<u>MODEL</u>	LC26P55E	LC32P55E	LC37P55E	LC26P70E
	LC32P70E	LC37P70E	LC32GA8E	LC37GA8E
	LC32GD8E	LC37GD8E	LC32BT8E	LC32GA9E
	LC37GA9E	LC32GD9E	LC37GD9E	LC26SA1E
	LC32SA1E	LC37SA1E	LC32SD1E	LC37SD1E
	LC37AD5E

SYMPTOM Set is dead and IC708 in the PSU section is defective

Reference – SP080601X

Figure1: IC708 and R832 location. Power supply schematic diagram location.

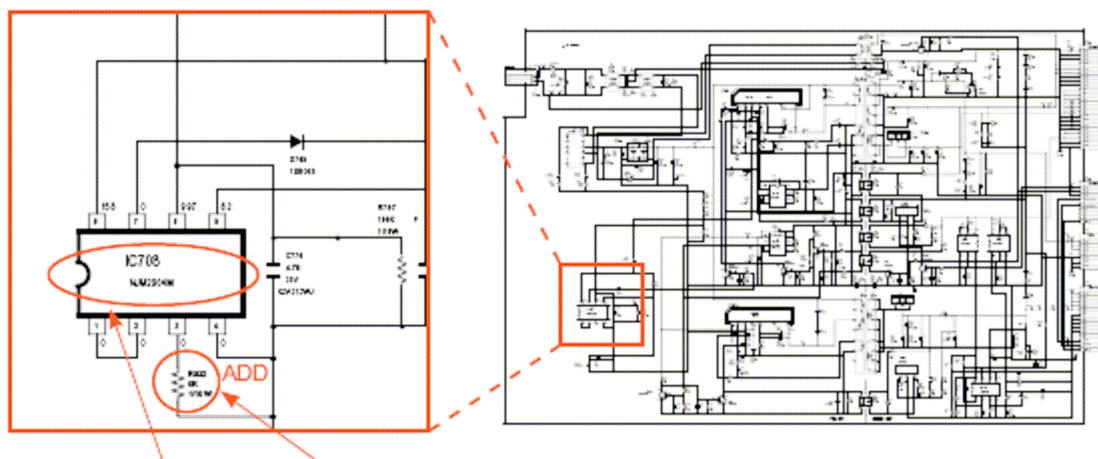
CAUSE IC708.

ACTION When replacing IC708 fit a zero resistor between pins 3 and 4 as shown in the added diagram figure1 and its location shown in figure 2.

<u>REF NO</u>	<u>DESCRIPTION</u>	<u>PART NUMBER</u>	<u>PRICE CODE</u>
IC708	NJM2904M	VHINJM2904M-1Y	AE
R832	0 Ohm 5% 1/10w SMD	VRS-TV1JD000JY	AA
